Construction Traffic Management Plan – Airport Business Park Station

SMWSASSM-PLD-ABP-TF-PLN-000001

Parklife Metro D&C

Traffic Management Road Safety Audit Report

FIGURE 7: PROJECTED ABP HV NUMBERS

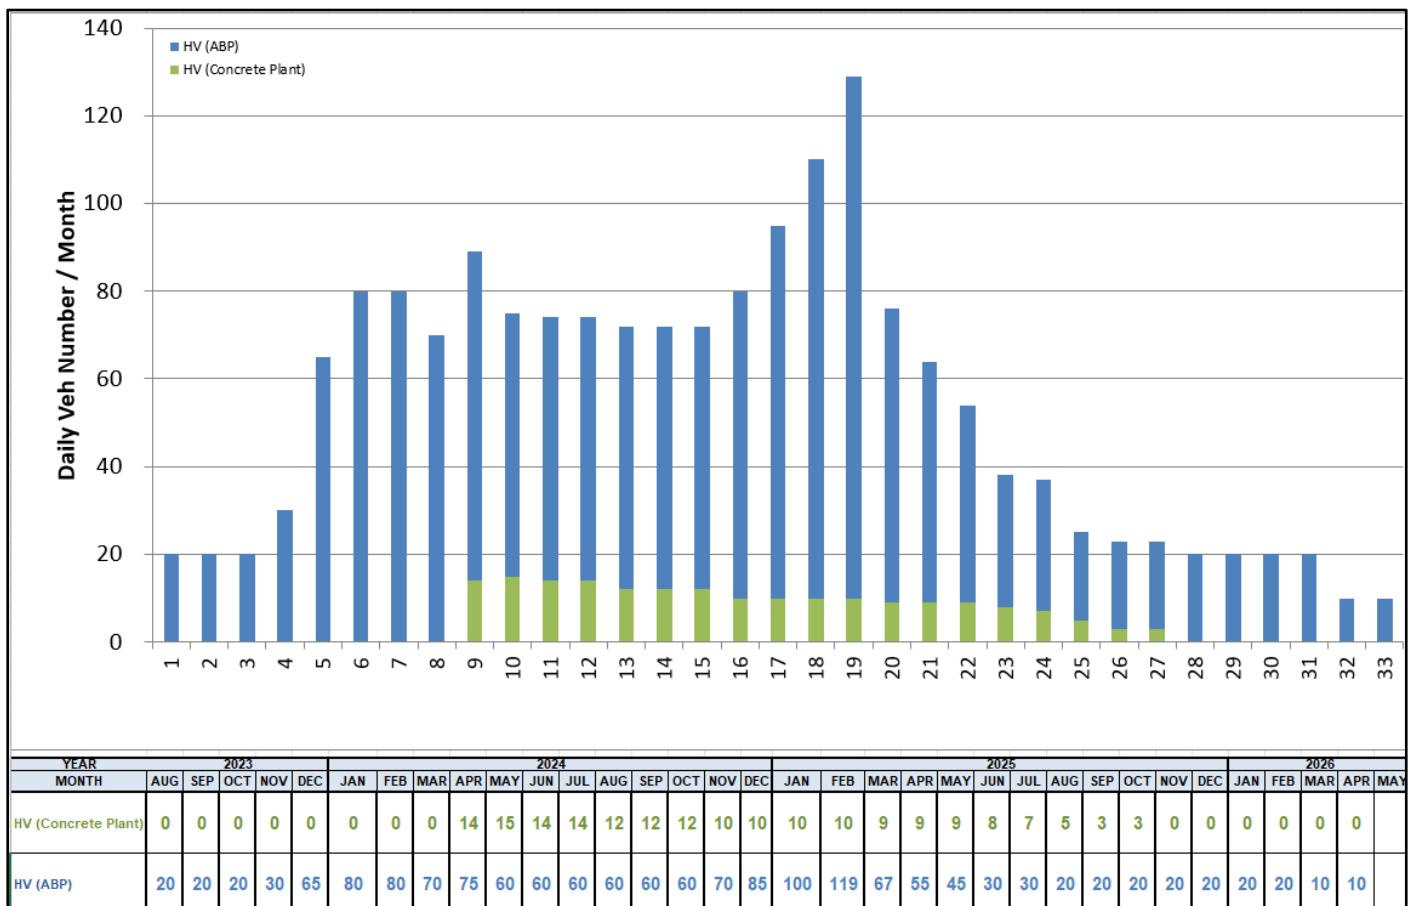
6/07/2023	PLD	WZHENG	SMWSASSM-PLD-ABP-TF-PLN-000001	Figure 10	NA	Figure 6 (was 10) has been updated to split the entering / exiting traffic	Observation		N
03	14/06/2023	TFN	LWILBY	SMWSASSM-PLD-ABP-TF-PLN-000001	Section 5.2 Pedestrian / Cyclist Impact Management	NA	Consider adding that there is also a wide sealed shoulder between Elizabeth Dr and Pitt St that provides greater space for cyclists and potential separation with heavy vehicles.	Observation		N
	6/07/2023	PLD	WZHENG	SMWSASSM-PLD-ABP-TF-PLN-000001	Section 5.2 Pedestrian / Cyclist Impact Management	NA	Updated in Section 5.2	Observation		N
04	14/06/2023	TFN	LWILBY	SMWSASSM-PLD-ABP-TF-PLN-000001	Appendix D Road safety audit	CTMF requirements	It appears that the road safety audit has been accidentally left off the document upload (finishes on page 31 of 39). Please upload additional pages with completed road safety audit as per the requirements in the CTMF.	Actual Non-Compliance		N

FIGURE 8: CONSTRUCTION VEHICLE ACCESS ROUTE

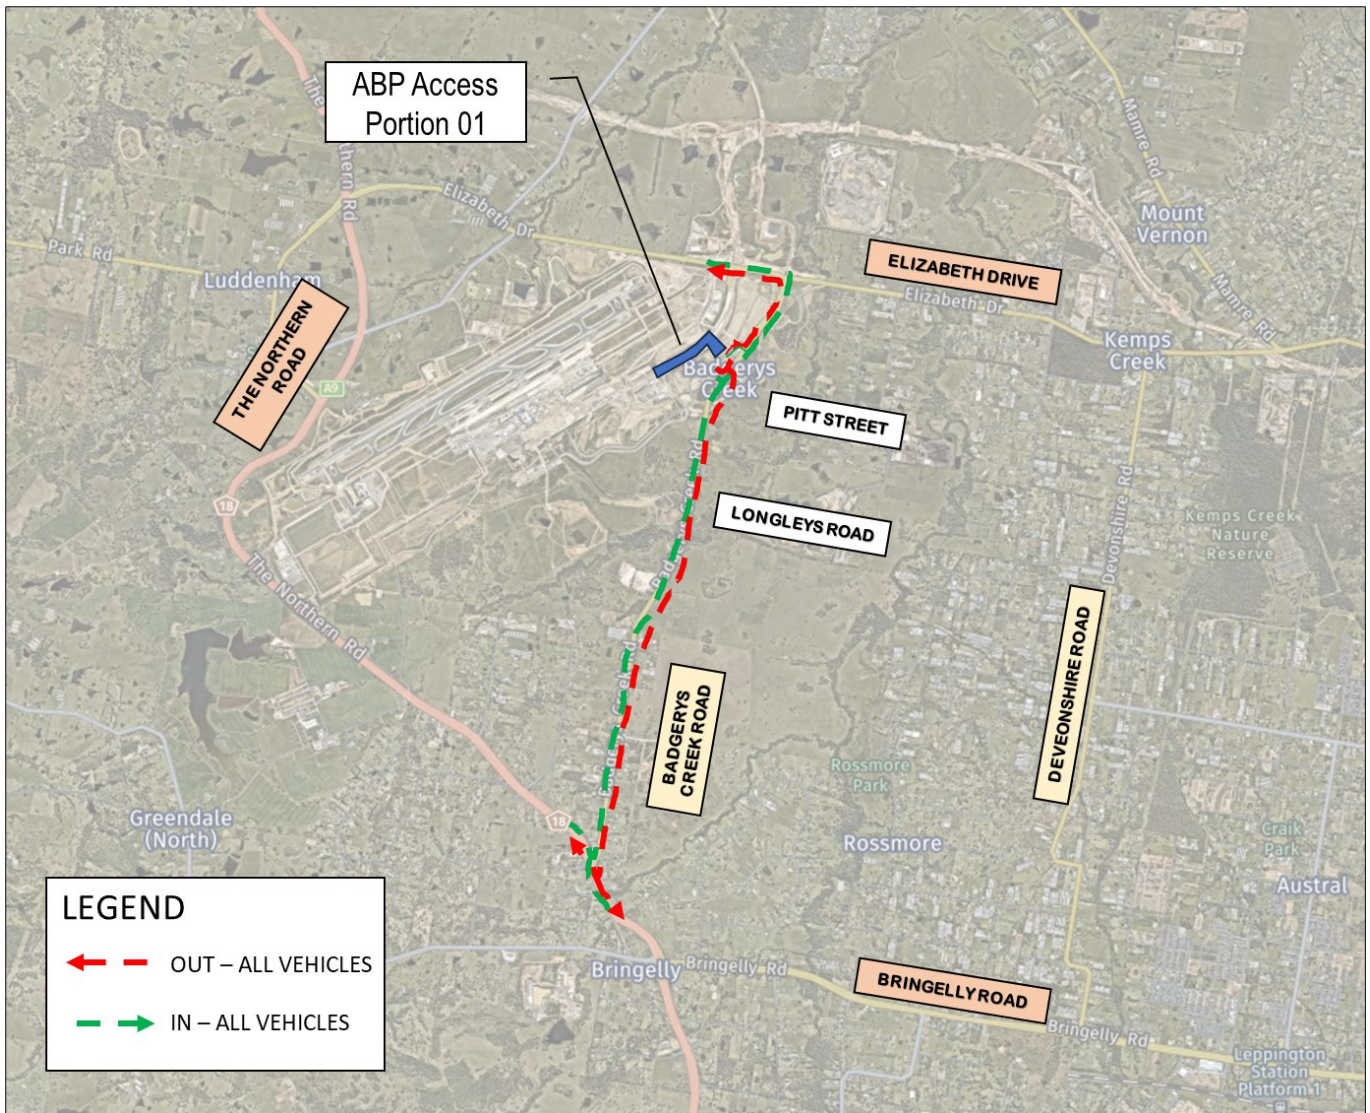
NO.	DATE	COMPANY	RAISED BY	REVIEW DOC. NO.*	DOCUMENT REF*	DEED REF*	COMMENTS / RESPONSE	COMMENT CATEGORY*	LINKED ITEM NO	CLOSED OUT
01	14/06/2023	TFN	LWILBY	SMWSASSM-PLD-ABP-TF-PLN-000001	4.6.2 Truck routes	NA	The paragraph on figure 7 correctly states that no bicycle paths available along either route, however cyclists may be legally riding along the road with general traffic. Consider updating wording, and site specific awareness for drivers to reflect this.	Observation		N
	6/07/2023	PLD	WZHENG	SMWSASSM-PLD-ABP-TF-PLN-000001	4.6.2 Truck routes	NA	Drivers to site will be all licenced and be made aware of cyclists on road through the following measures: - toolbox talks - inductions - Sydney Metro Safe Heavy Vehicle Driver Introduction Programme (Appendix E) - Drivers Code of Conduct (Appendix E) - NSW Road Rules Act 2014 Section 5.2 has been updated accordingly	Observation		N
02	14/06/2023	TFN	LWILBY	SMWSASSM-PLD-ABP-TF-PLN-000001	Figure 10	NA	Figure 10 appears to show an exiting vehicle short cutting in the wrong direction through the roundabout at Pitt Street. Please update to show correct route.	Observation		N

Figure 3: Proposed site access arrangements – Access Portion 01

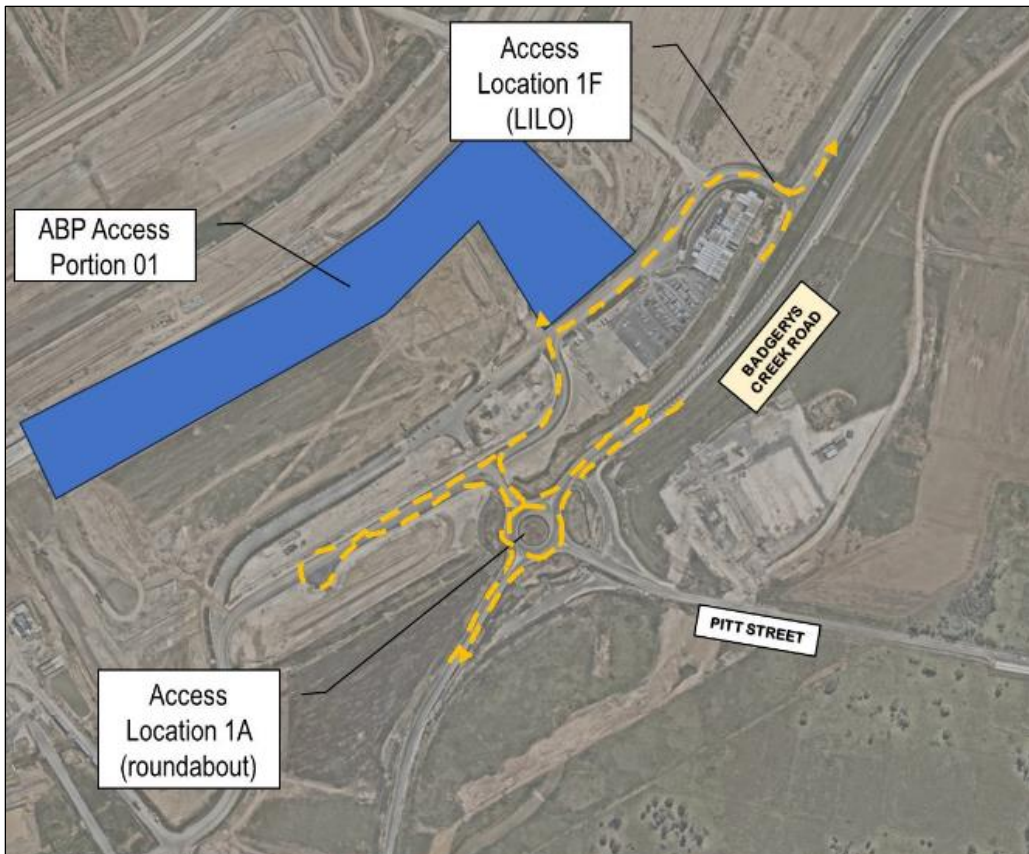
- all vehicles that access from Location 1A will be required to turn left to go south and use the P-turn to go north
- no additional traffic control is proposed at either access locations

- the access arrangements within the Access Portion 01 has not been detailed within the CTMP and therefore could not be assessed in this audit
- a Traffic Guidance Scheme (TGS) has not been detailed in the CTMP at the time of this audit, and therefore could not be assessed.

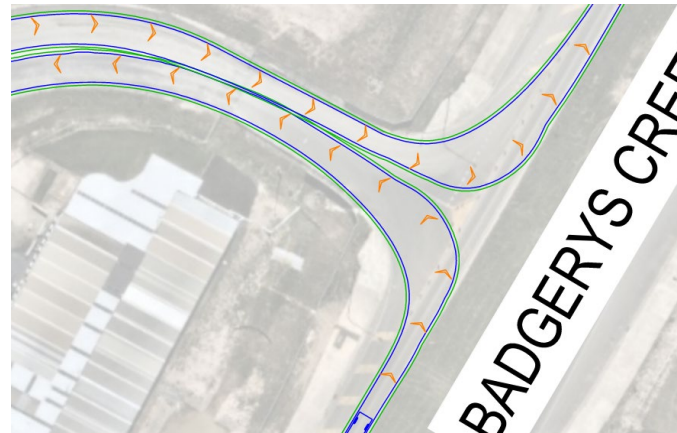
1.4. The swept paths indicate that heavy vehicles must turn left in from the through lane at access 1F.

Light vehicles may attempt to enter the left turn lane whilst a heavy vehicle is turning left in from the adjacent through traffic lane.

This may result in a side swipe crash.

Likelihood:
Rare
Severity:
Serious
Risk rating:
MEDIUM

Revised swept path with 19m AV show HV can turn left from left lane at access 1F. LVs will queue behind HVs and vice versa.
